Re: Erie Land Company, LLC – Preliminary Plat and PUD Rezoning  
(PP-001038-2019 and PUD-001039-2019)

**Subject: Westerly Preliminary Plat PP-001038-2019 – Resubmittal**  
**Town of Erie, Weld County, CO; CGS Unique No. WE-19-0046\_2**

**TO:** Hannah Hippely  
**FROM:** Charles M. Buck, P.E., PTOE  
**DATE:** January 15, 2020  
**SUBJECT:** Review of Preliminary Plat  
Westerly  
PP-001038-2019  
FHU # 95-190

**TO:** Hannah Hippely  
**FROM:** Charles M. Buck, P.E., PTOE  
**DATE:** April 4, 2019  
**SUBJECT:** Review of Preliminary Plat and Planned Unit Development  
Westerly  
PP-001038-2019 & PUD-1001039-2019  
FHU # 95-190

**Figure 5  
SITE PLAN**

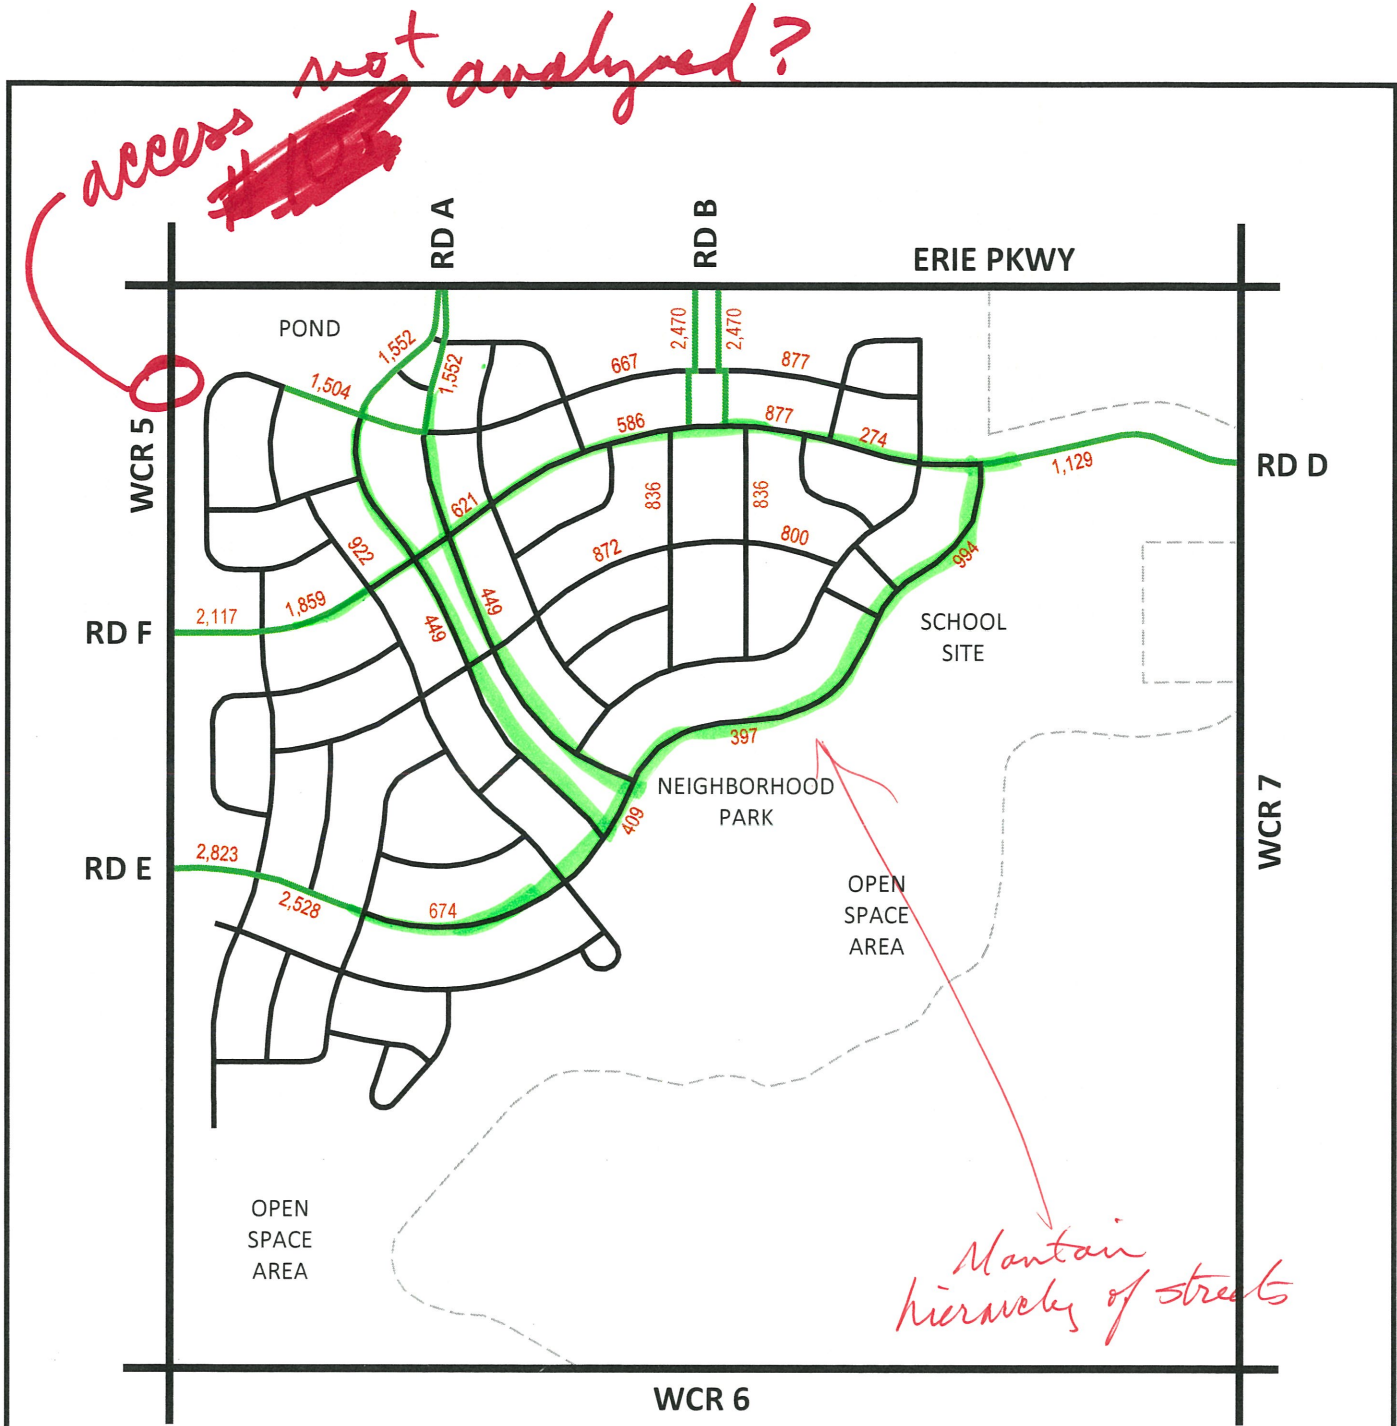
4. Figure 5 shows a site plan concept. This figure shows an additional access to WCR 5 that was not analyzed in the TIS (see Figure 11).
5. Figure 11 shows daily site volumes. I have marked, in green, the internal roads that would function as collectors. This comment also applies to the Preliminary Plat. I do not object to homes fronting these roadways along segments where the traffic volumes are below the 1,000 ADT threshold.

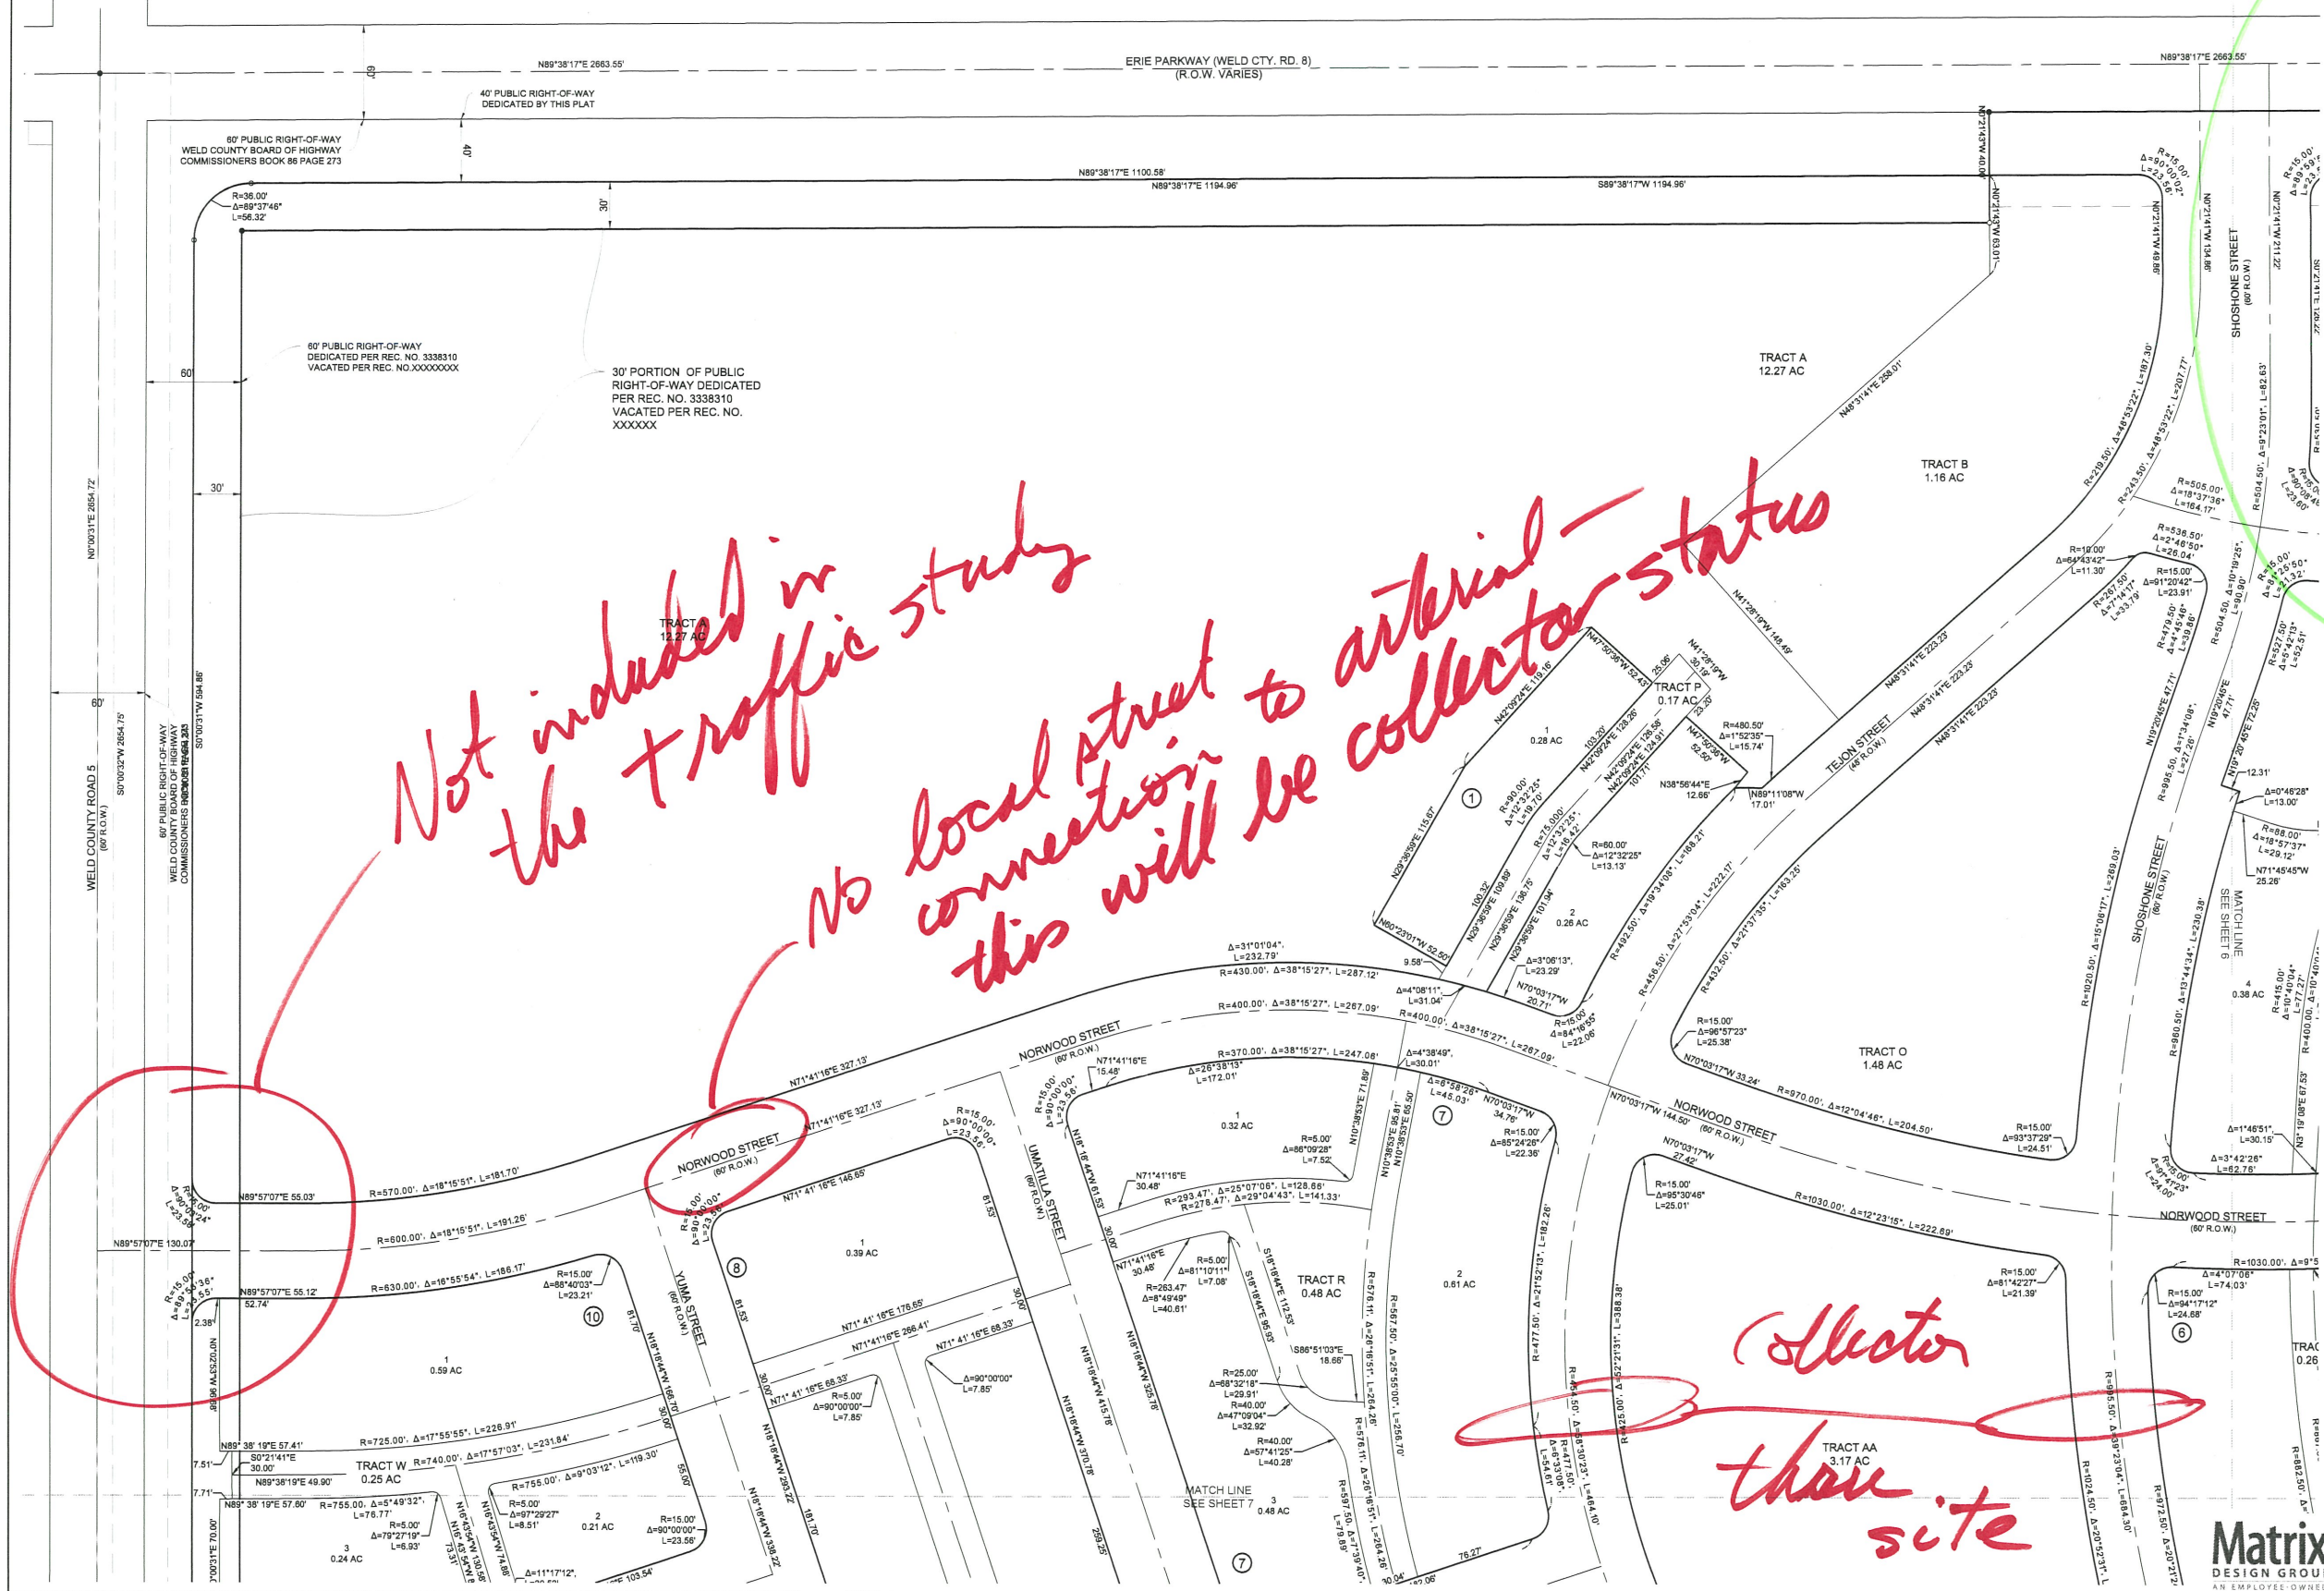
→ OK. BUT what about site related improvements? • Traffic control @ access  
• turn lane improvements  
• LOS F @ some locations  
what could improve?

SHEET 5 OF 16  
DATE: 2019-02-04  
SURVEYOR  
MATRIX DESIGN GROUP  
1601 BLAKE STREET, SUITE 200  
DENVER, CO 80202  
(303) 572-0200  
CONTACT: BOB MEADOWS  
bob\_meadows@matrixdesigngroup.com

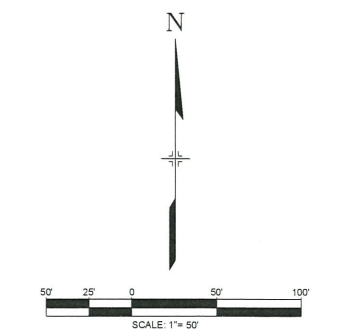
9. Sheet 5 of 16 – The access on WCR 5 (Norwood) is not included in the TIS (see comment # 4 above). This is shown as a local road. Please maintain the hierarchy of streets; collector status is needed for street access to arterials.

10. Sheet 5 of 16 - How is Shoshone/Tejon intended to function? Is this a one-way couplet? Landscaping plans for the center median areas will need to consider appropriate sight distance criteria.

collector

SHEET 6 OF 16

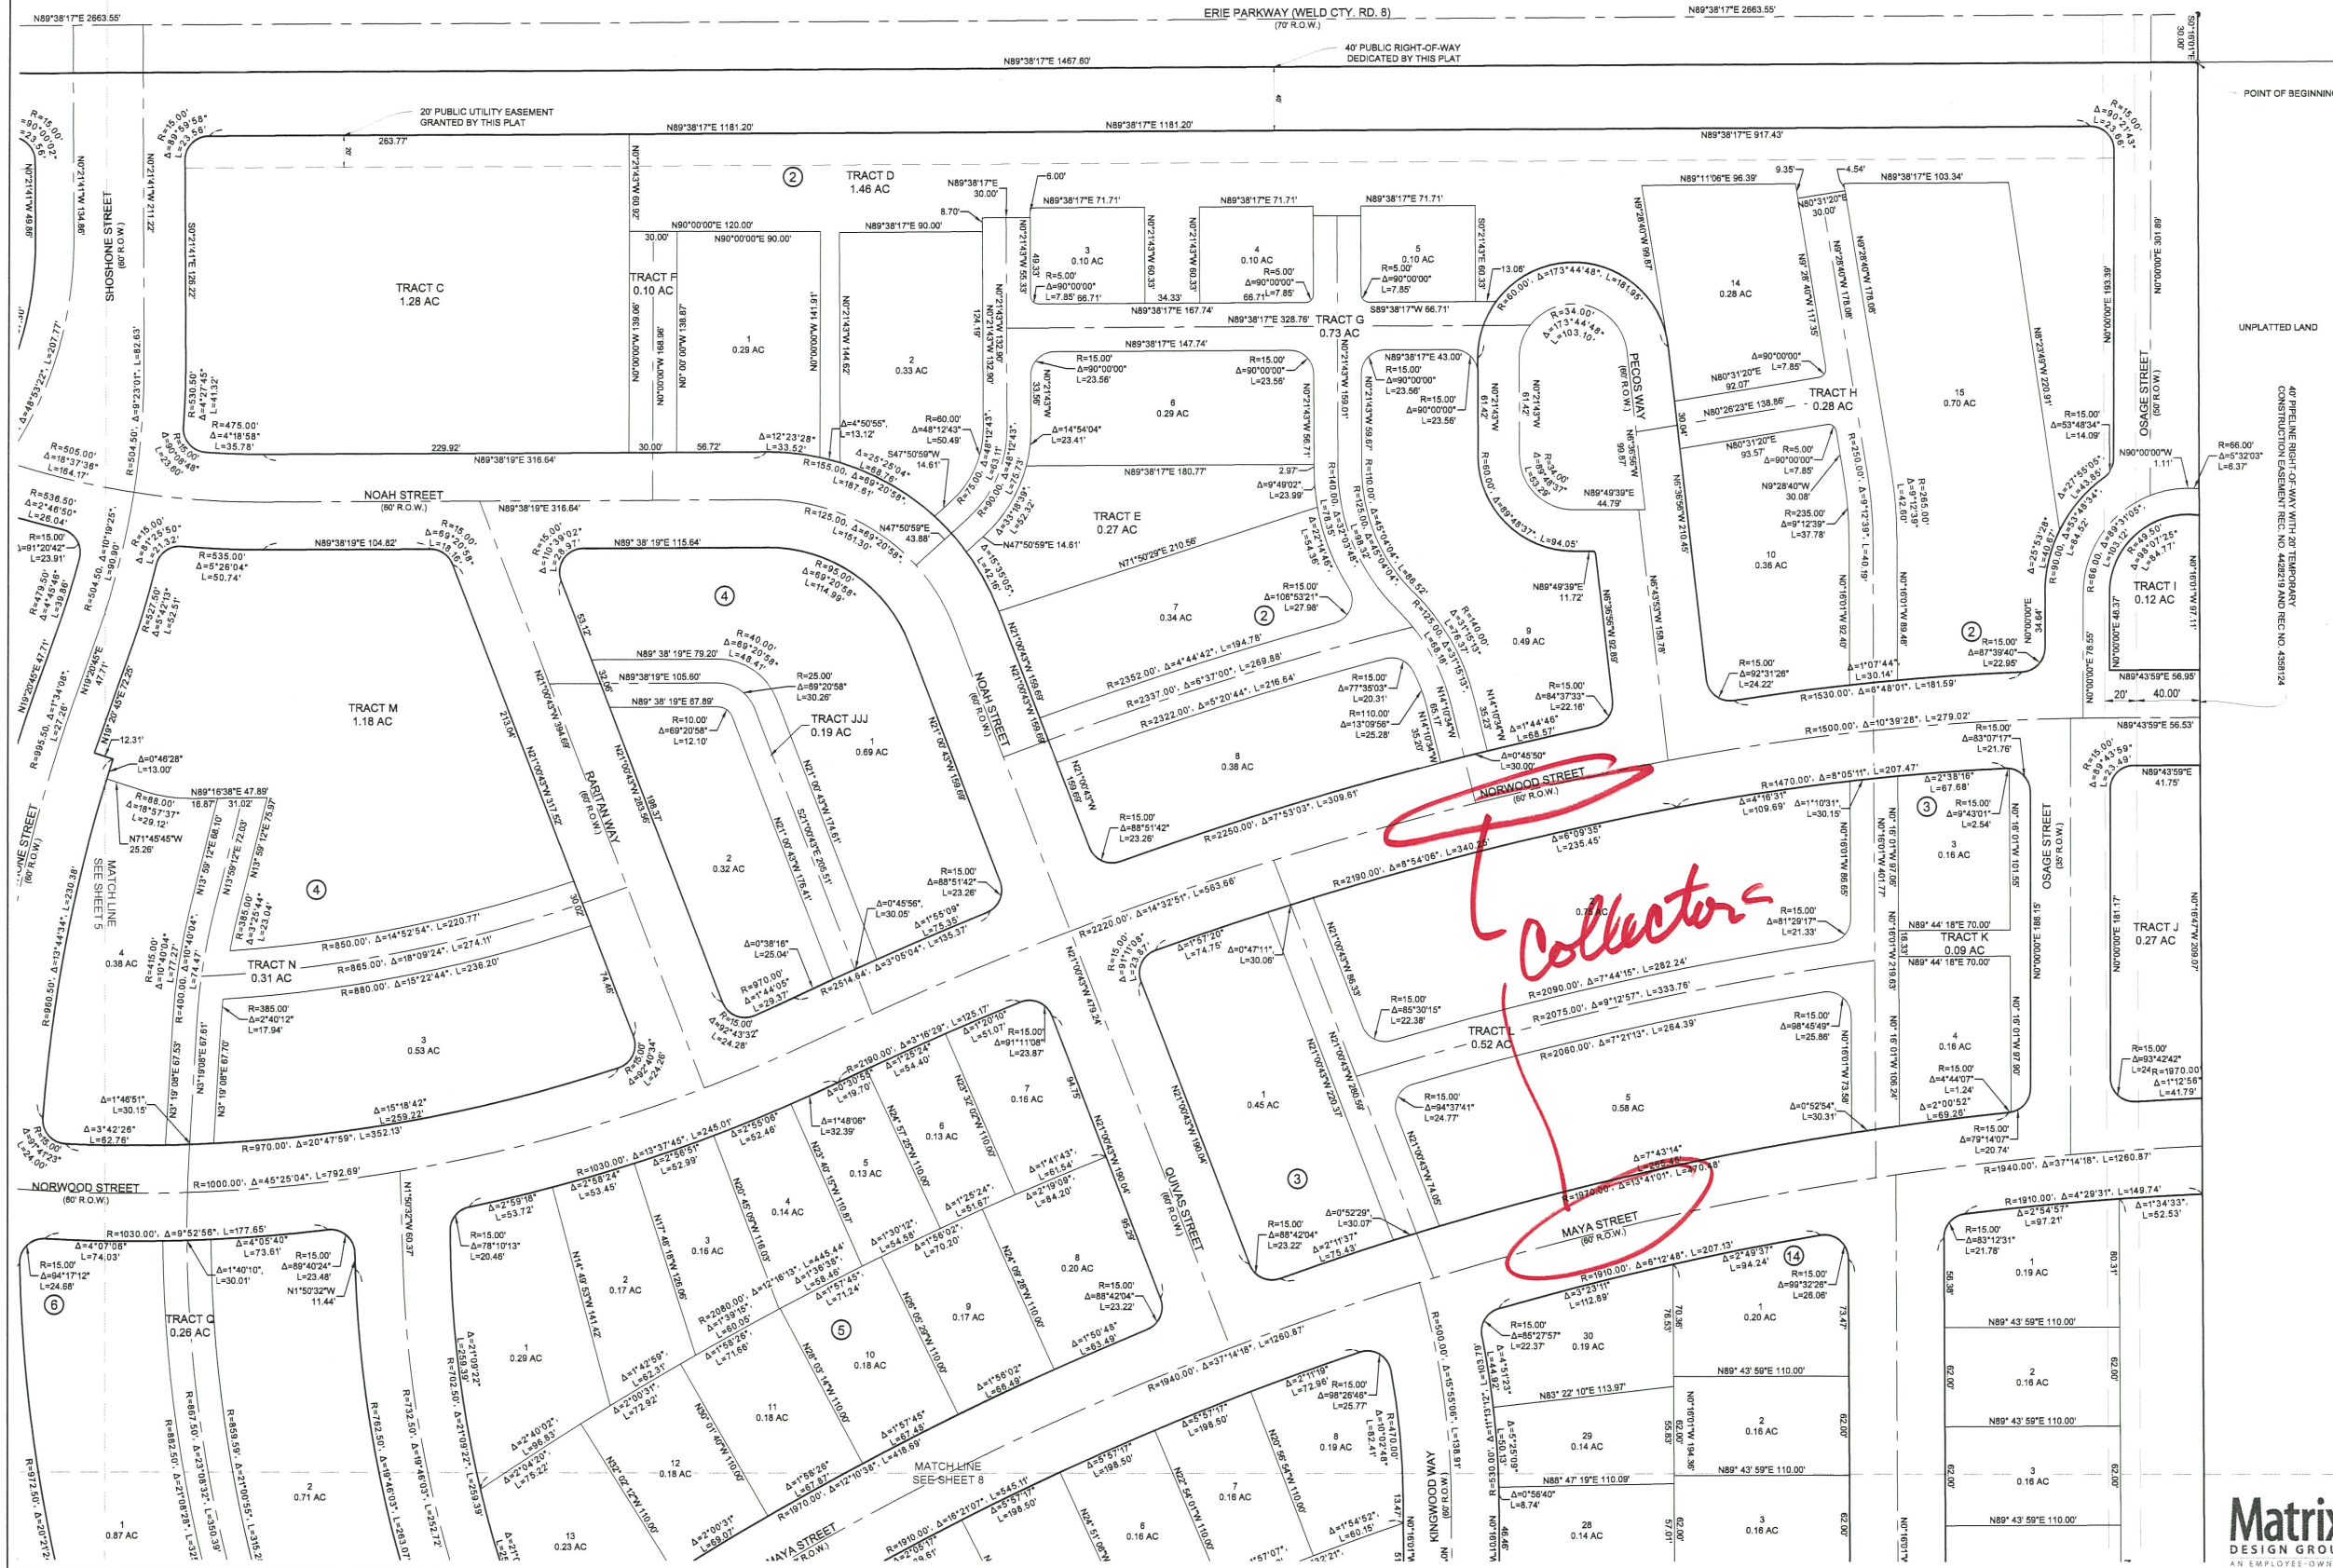
11. Sheet 6 of 16 - The intersection of Shoshone/Tejon is an unusual configuration. Future studies will need to address traffic control and sight distance at this intersection.

12. Sheet 6 of 16 – Both Norwood (assuming it connects to WCR 5) and Maya are functionally collector roadways. Use Town of Erie collector cross-sections.
